**MAJOR PROJECT ASSESSMENT:
Concept Plan and Stage 1 Project
Application at the Shepherd's Bay
Foreshore, Meadowbank and Ryde
(MP09_0216 and MP09_0219)**

Director-General's
Environmental Assessment Report
Section 75I of the
Environmental Planning and Assessment Act 1979

December 2012

Figure 17: Proposed and existing building RLs along Belmore Street (Base Image Source: Proponent's PPR)

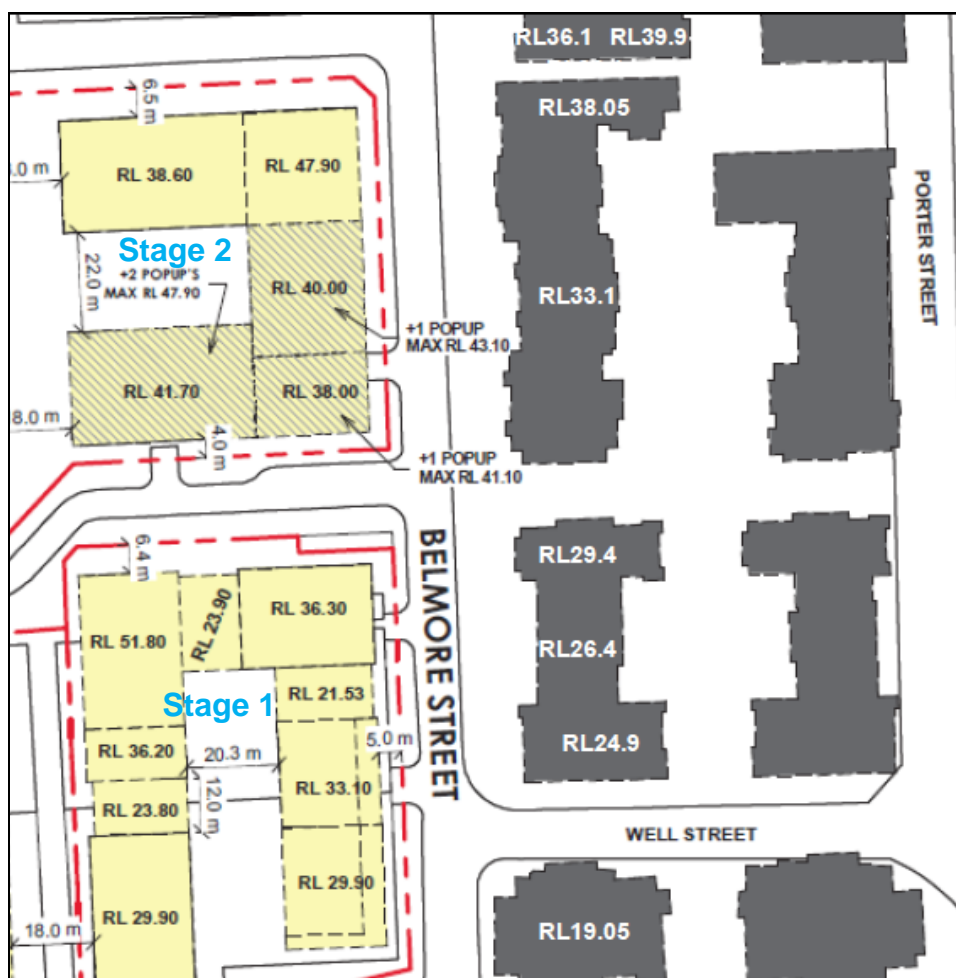
The recently constructed 'Bay One' development on the eastern side of Belmore Street typically presents as 5 to 6 storeys in scale, including an upper floor which is generally setback from the main building line as seen in **Figure 16**. To allow comparison with the proposed development in terms of RLs, the level of the upper roof lines of the Bay One development (in RLs) are also included in **Figure 17**.

The proposed changes still result in heights up to 1 – 2 storeys greater than existing development on the opposite side of Belmore Street but allow for a 'stepping down' in built form to achieve a more coherent height transition and appropriate contextual relationship with the character of the surrounding area.

- Replace RL 47.90 with RL 41.90 (6 metres or 2 storey reduction);
- Replace RL 40.00 with RL 37.00 and Popup RL 43.10 with RL 40.10 (3 metres or 1 storey reduction); and
- Replace RL 38.00 with RL 35.00 and Popup RL 41.10 with RL 38.10 (3 metres or 1 storey reduction)

Figure 18: Areas of proposed envelopes within Stage 2 recommended for deletion (Base Image Source: Proponent's PPR)

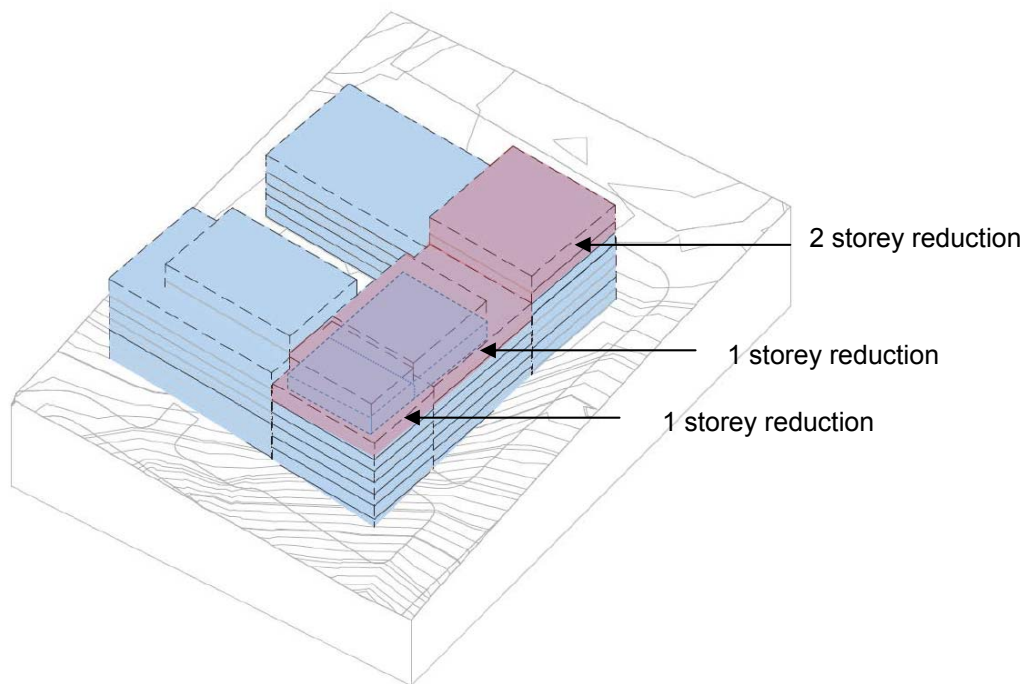
These changes are depicted in **Figure 18**.

Figure 19: Proposed RLs along the foreshore (Base Image Source: Proponent's PPR)

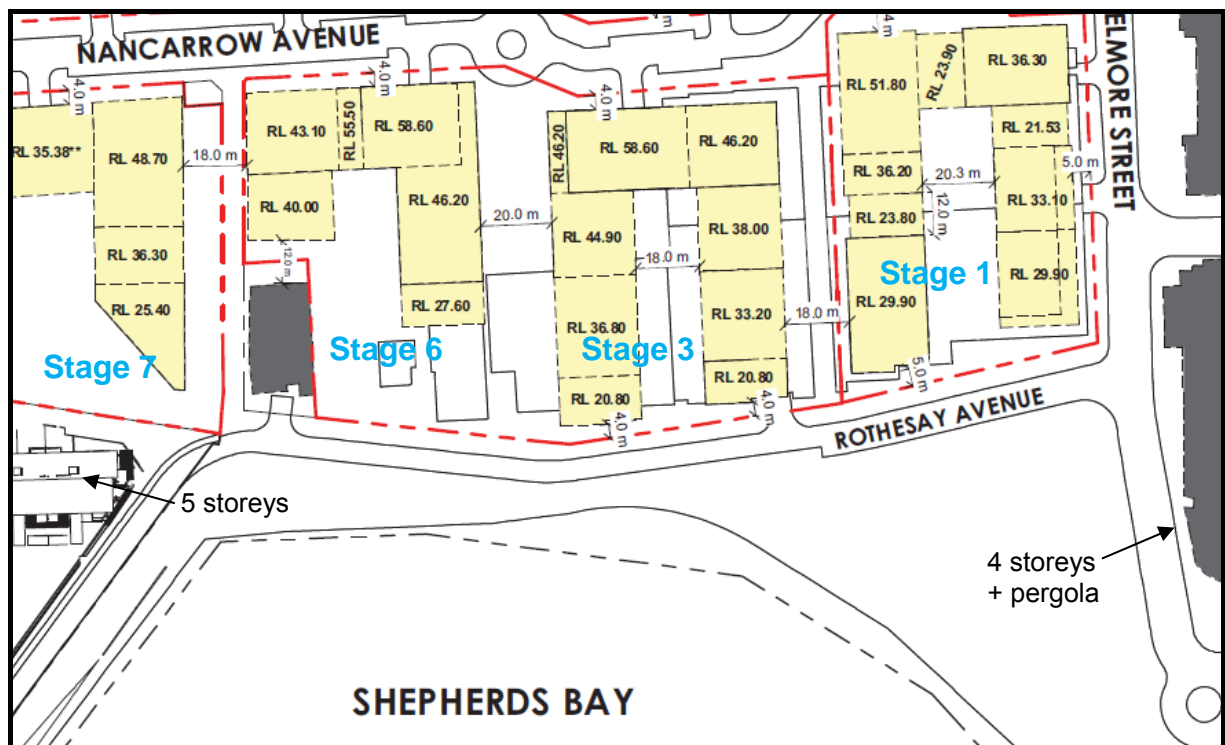
The proposed building envelopes have generally been designed to step down in scale towards Rothsay Avenue, or as they present to the foreshore. The proposed building envelopes include RLs which would permit a range of heights for buildings fronting Rothsay Avenue and the foreshore as shown in **Table 5** and **Figure 19**.

The department considers that a stepping down in built form in this area is necessary to reduce the visual impact of the proposal as it presents to the foreshore and the waterway and to minimise amenity impacts for users of the foreshore area, particularly to ensure a human scale that does not create a sense of overbearing and to minimise overshadowing of this area. A height equivalent of 5 storeys is appropriate, having regard to the LEP controls and the heights of adjoining development. A height equivalent to 6 storeys for Stage 6 is acceptable given that it will be well setback behind the adjoining building lines and therefore would be less dominant as viewed from the public foreshore area.

Figure 22: Proposed and existing building RLs along Bowden Street (Base Image Source: Proponent's PPR)

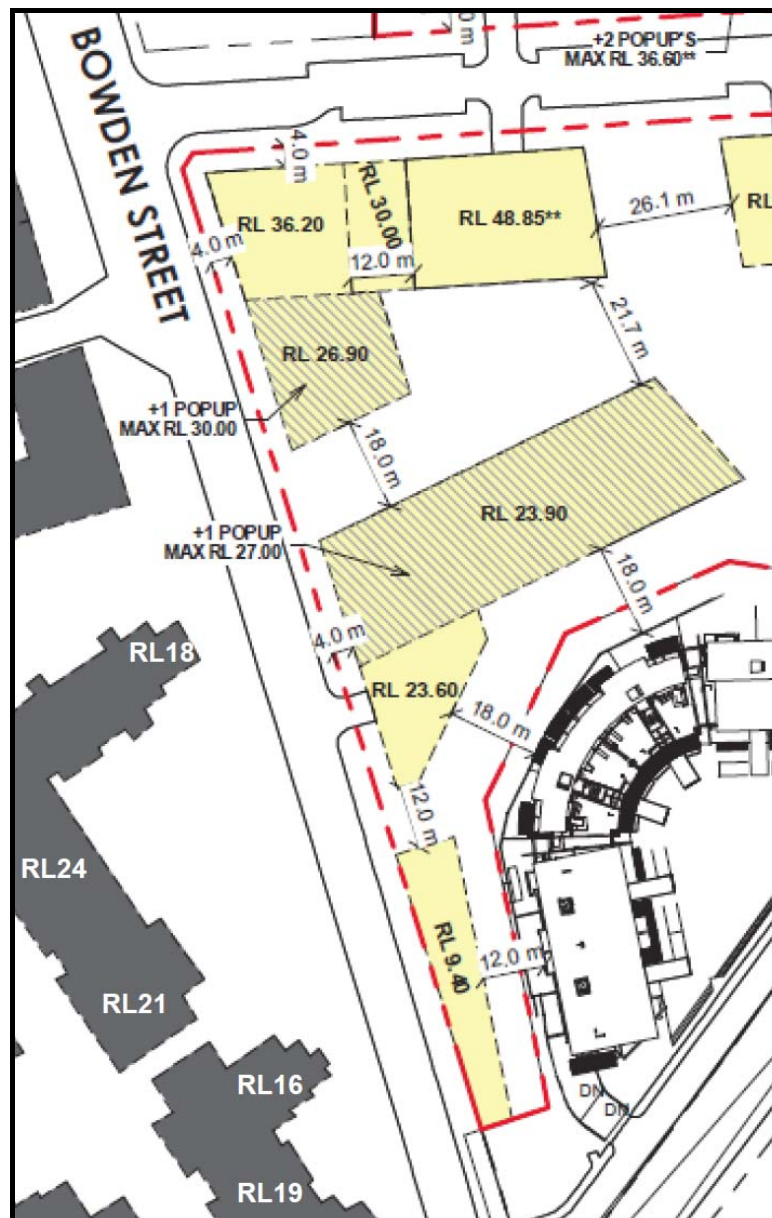
Approximate RLs for the adjoining Waterpoint Development are indicated in **Figure 22**. Sites to the north on Bowden Street are yet to be developed, but under the draft RLEP 2011, could achieve a height of 21.5 metres (equivalent to 7 storeys or RL 32 adjacent to Underdale Lane). The proposed building envelopes along Bowden Street are considered to provide a reasonable transition to the existing and likely future scale of development on the opposite side of Bowden Street and no further amendments of proposed building envelopes in this location are considered necessary.

Council raised a concern that the building envelope of the intended single storey building on Bowden Street permitted an excessive floor to ceiling height. The site is intended to be developed as a single storey café / kiosk, and the proposed building envelope permits a total height of approximately 6.5 metres. This is considered to be an acceptable height in the context of surrounding development and permits a high level of internal amenity with good internal floor to ceiling height as well as the ability to include a pitched roof or other architectural features to the roof form to complement the proposed use. See also **Section 5.2.2** in relation to street setbacks for this building.

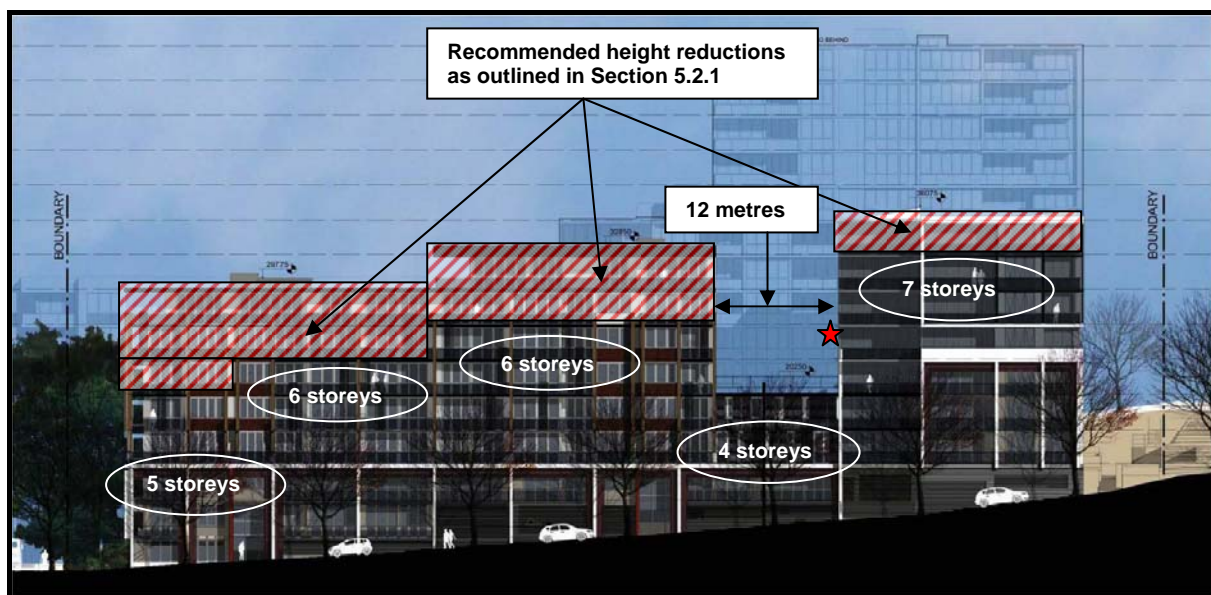
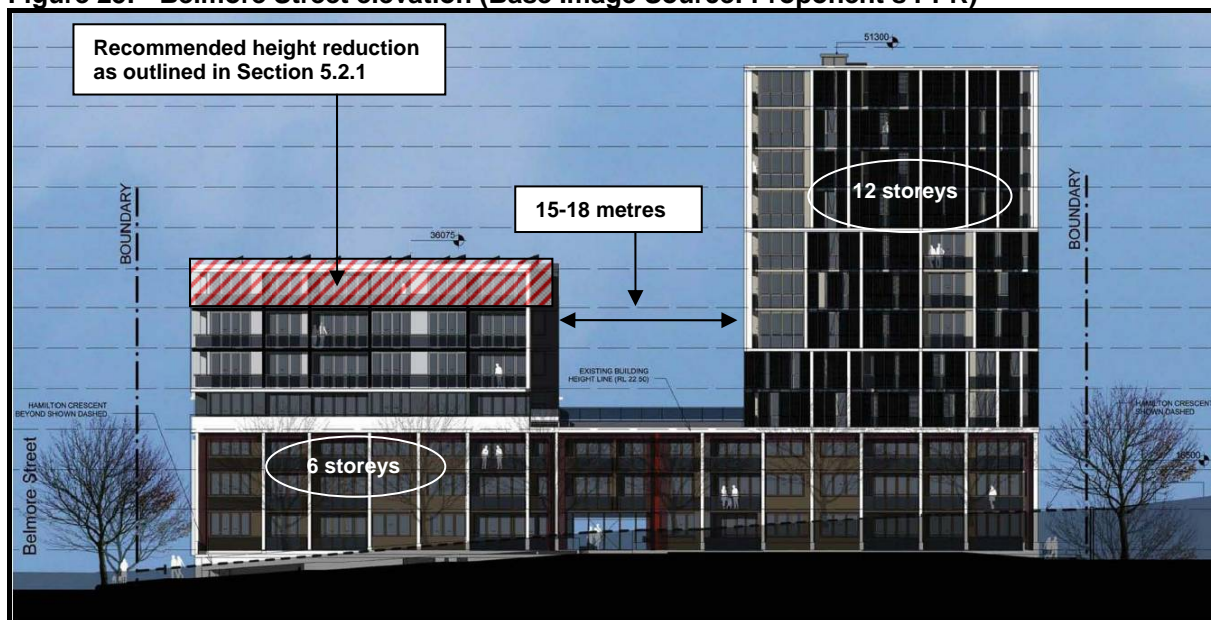
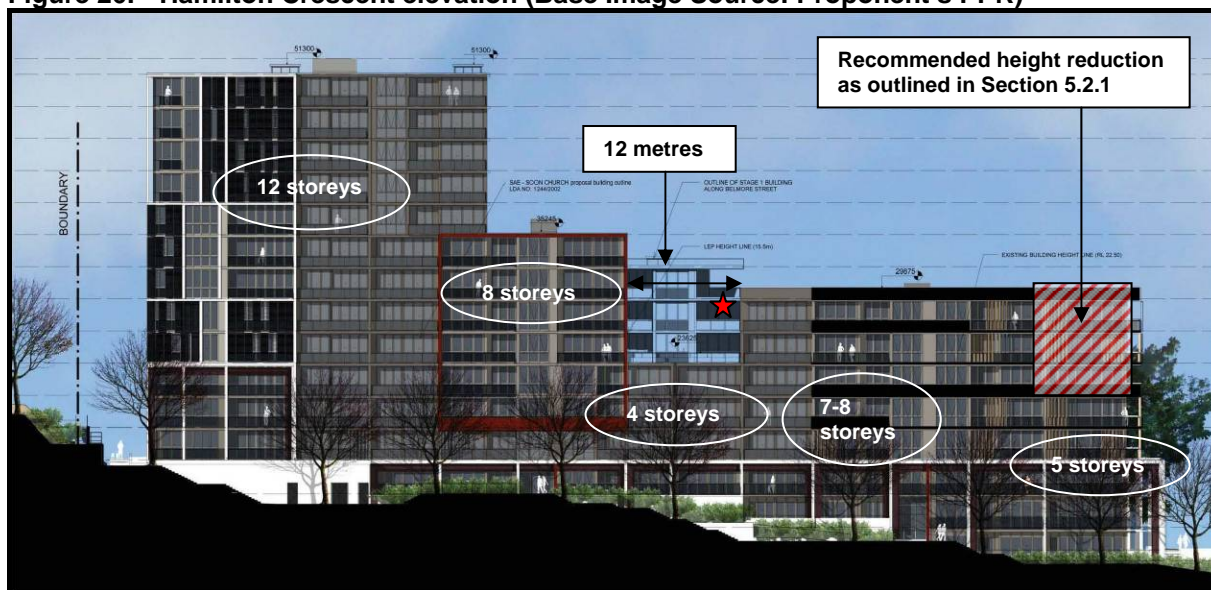
The proposal provides between 12 and 18 metres separation in these locations (refer to **Figures 25, 26 and 27**). The proponent considers that the separation complies with the RFDC guideline on the basis that a podium is provided by the lower levels of the buildings which establishes a new ground plane (thereby reducing separation requirements).

Strict application of the RFDC guideline would require 18 metres separation in each of these locations. The department is satisfied that 12 metres is adequate separation along the Belmore Street and through site link frontages. The recommended reductions in height as outlined in **Section 5.2.1** will assist in reducing the visual bulk of the building along these frontages. In addition, visual privacy can be provided by increasing the sill height of windows to two apartments marked with a red star in **Figures 25 and 27**. On the level below, the landscaped roof terrace provided to each of these apartments will provide adequate privacy between apartments.

It is recommended that the 15 metre separation along the Hamilton Crescent frontage be increased to 18 metres in line with the RFDC. As this is the north-eastern elevation, any increased setback will provide an improvement in solar access to the development.

Figure 28: Stage 5 building envelope showing the proposed separation between the two towers (Base Image Source: Proponent's revised PPR)

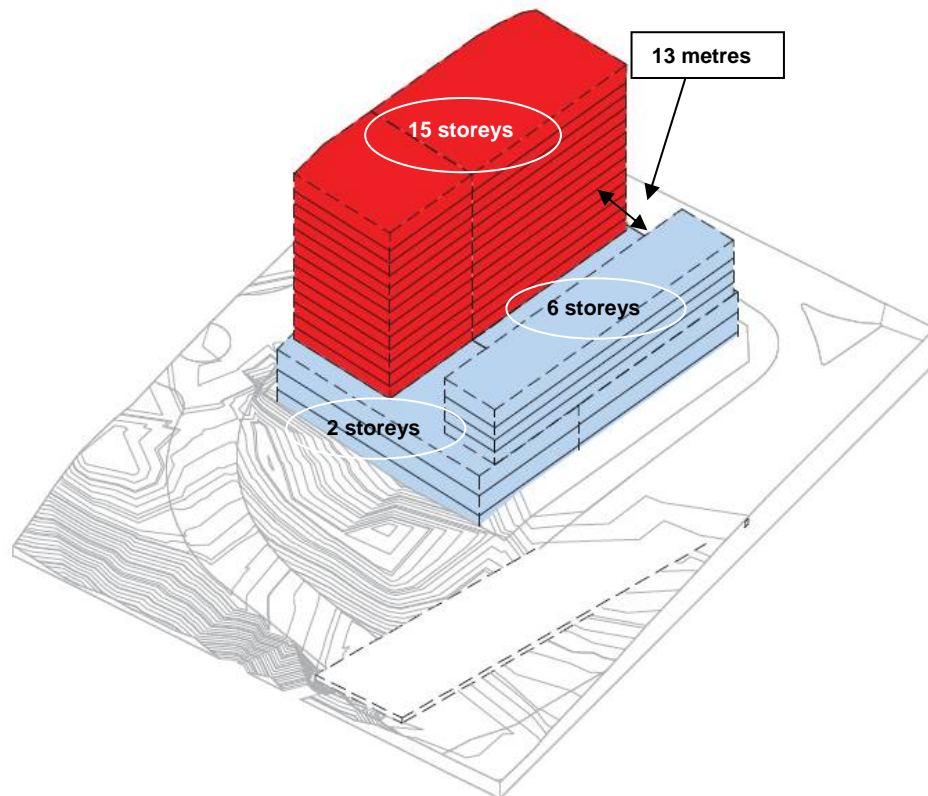
The proposal provides a 13 metre separation between the two tower elements of the signature building on the Church Street site as shown in **Figure 28** below.

In order to incorporate windows to habitable rooms in both elevations of buildings above 5 storeys, the RFDC recommends that 18 metres be provided. Notwithstanding, the RFDC acknowledges that 13 metres is sufficient where habitable rooms face non-habitable rooms. The department considers that this is acceptable in this instance, noting that this can be assessed in detail in the future development application for the site. In addition, it is noted that the development application will involve articulation of the facades which will likely increase the setback between the two towers and that privacy can be achieved through offset windows and balconies and use of screens or other measures.

Figure 29: Stage 6 building envelope showing the proposed separation to the adjoining property to the south (Base Image Source: Proponent's revised PPR)

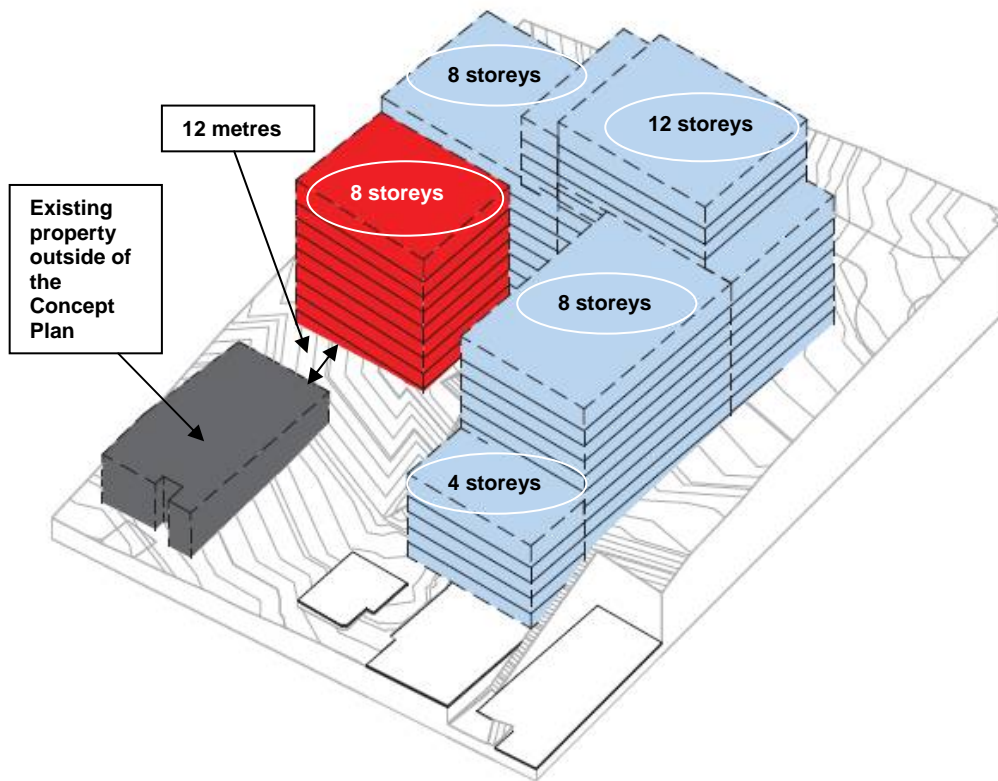
The proposal provides a 12 metre separation (approximately 5 metres on the subject site and 7 metres on the adjoining site) between the Stage 6 building envelope and the existing building on the adjoining site to the south as shown in **Figure 29**. The adjoining site is not within the Concept Plan site and it may be developed separately in the future. The proponent considers that this site may accommodate a 4 storey building if it was developed in accordance with the draft RLEP 2011 and RDCP 2011 controls for the site.

- 6 metres up to 4 storeys (to allow for a total of 12 metres); and
- 9 metres above 4 storeys (to allow for a total of 18 metres).

The department also considers that setting back the upper 4 levels of this portion of the Stage 6 building envelope, by an additional 3 metres than the lower 4 levels, will assist in reducing the bulk and visual impact from the foreshore.

Figure 31: Pedestrian and Cycle Access Plan (Source: Proponent's PPR)

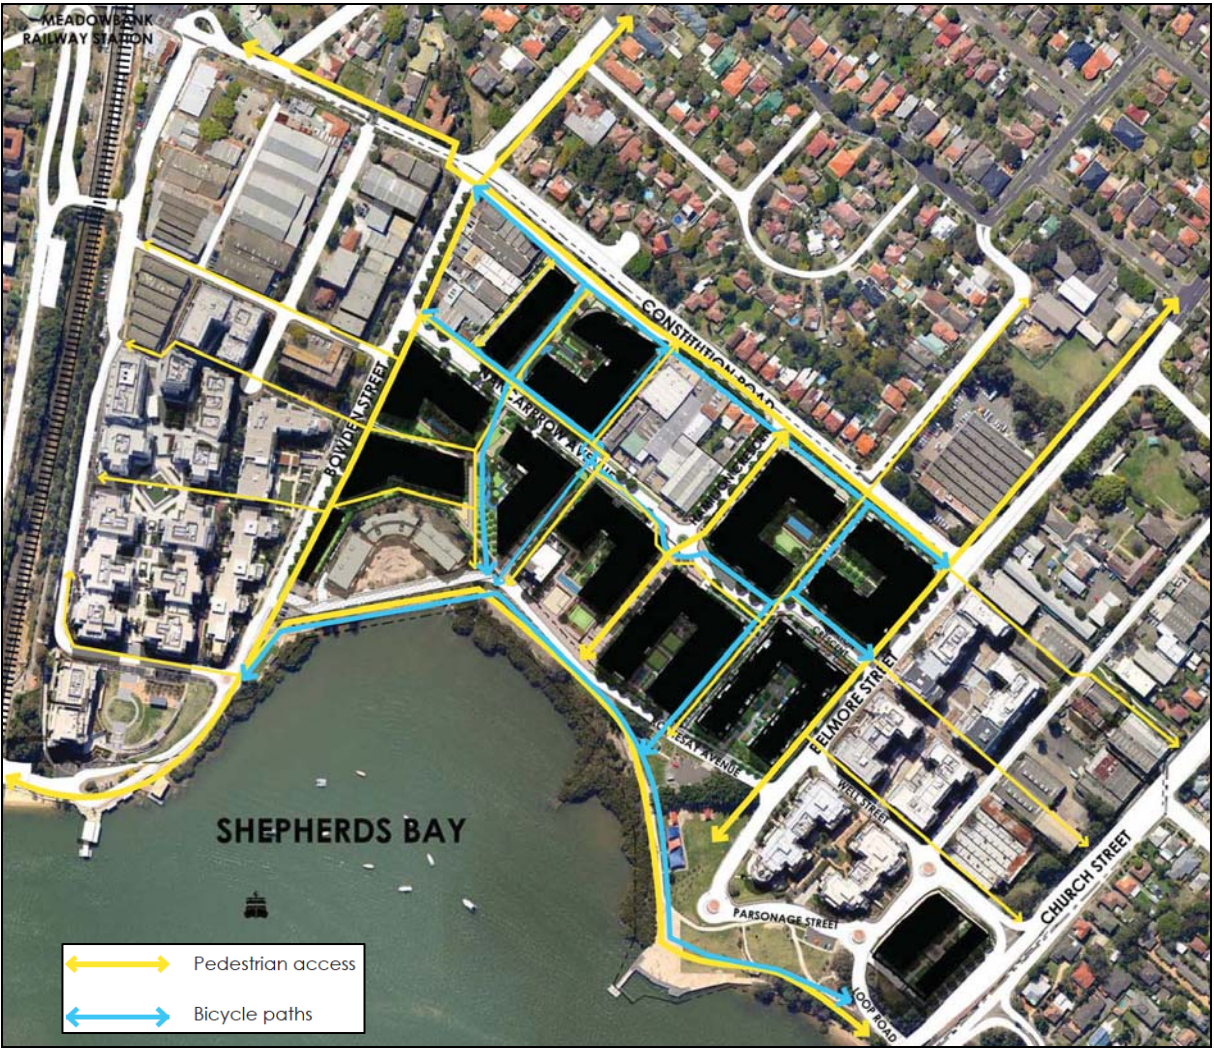
As discussed in detail below, the department considers that there are a number of inconsistencies between these two plans, the plans within the landscape report and with the description provided by the proponent.

While the Pedestrian and Cycle Access Plan (**Figure 30**) does not indicate that pedestrian paths will be provided along both sides of Nancarrow Avenue and Hamilton Crescent, the Accessible Circulation plan does (see **Figure 31**). However, no accessible pathways are indicated along Bowden Street, Constitution Road, or Belmore Street. The department considers that it is essential for a development of this density to provide pedestrian pathways accessible for all persons on both sides of the street within all road reserves adjacent to the development.
